Access Compliance Report

Public Rights-of-Way

(Pedestrian Signals)

Intersection ID: N/A	Main Street:	Cross Street: N/A	Location: N/A
ADA ID: ADCB9307386B	Signal Type: One Push Button-APS	Overall Compliance: No	Severity Score: BTN 1: N/A BTN 2: N/A No BTN: N/A
Codes/Mitigation Info/Possible Solution		Field Measurements/Component Compliance

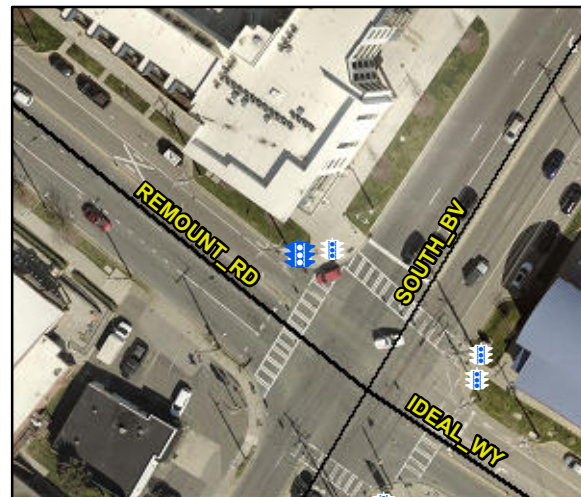
Surveyor Notes: BTN DAMAGED

PROW/ADA: R404.2, R404.3, R209.1, MUTCD 4e.10

Possible Solutions: Remove & Replace
Replace APS Button With New APS Button.
Remove and Replace Clear Space.
